UNITED STATES PATENT AND TRADEMARK OFFICE

Office Action Summary

09/319,842

DETAILED ACTION

Fig. 2

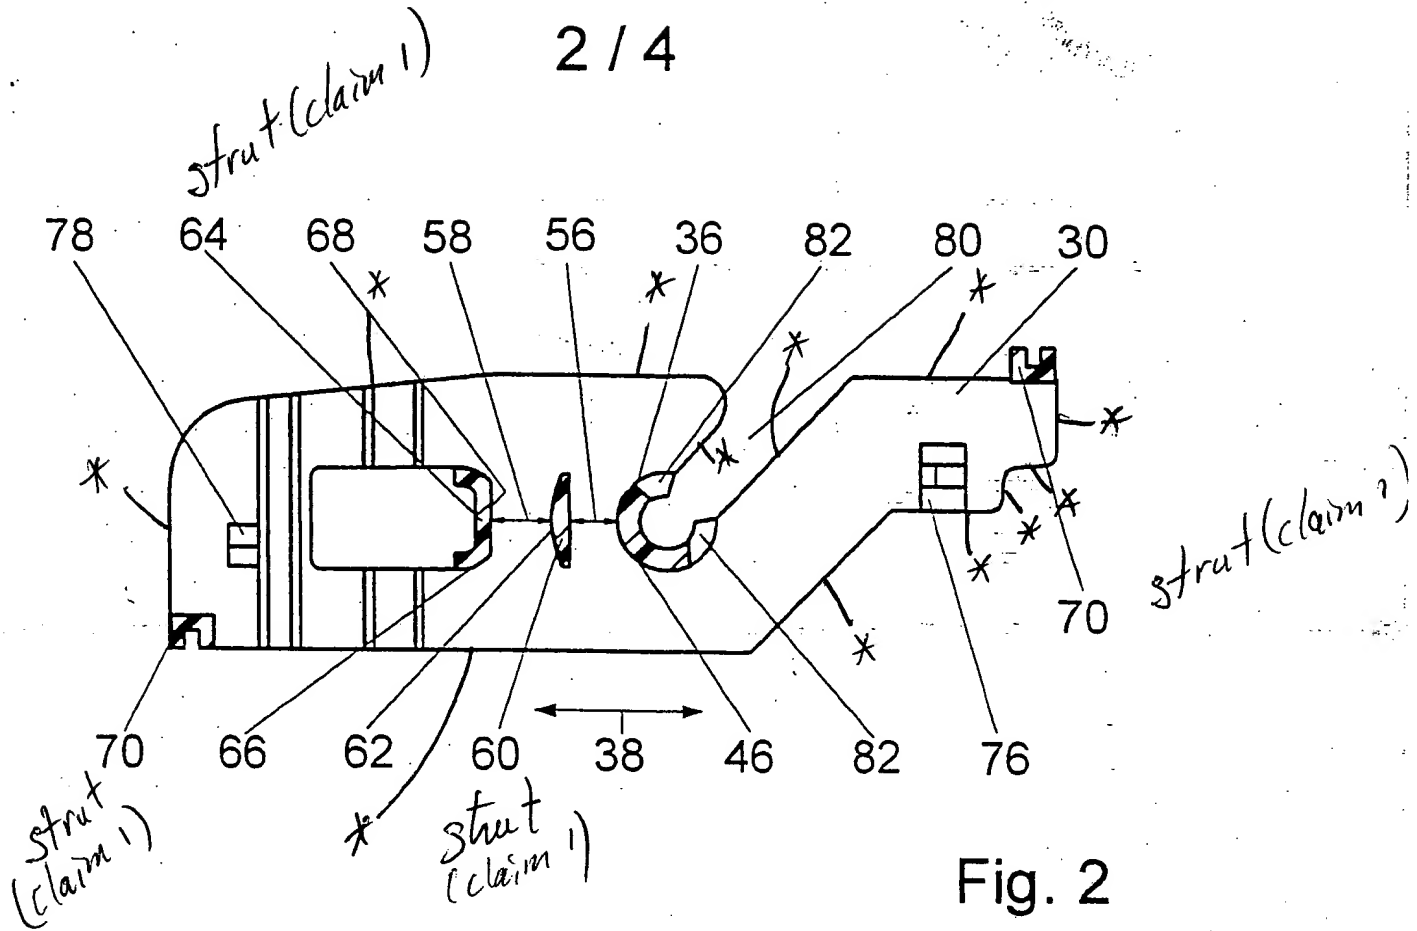
The drawings are objected to under 37 CFR 1.83(a). The drawings must show every feature of the invention specified in the claims. Therefore, the additional lateral strut disposed at ends of the side walls (claim 6) must be shown or the feature(s) canceled from the claim(s). No new matter should be entered. Applicant is reminded that applicant's drawings show two side walls each one having numerous ends (see attachment). Struts 60, 64 and 70 are covered by claim 1 and shown in Figure 6.

* Ends without an additional strut
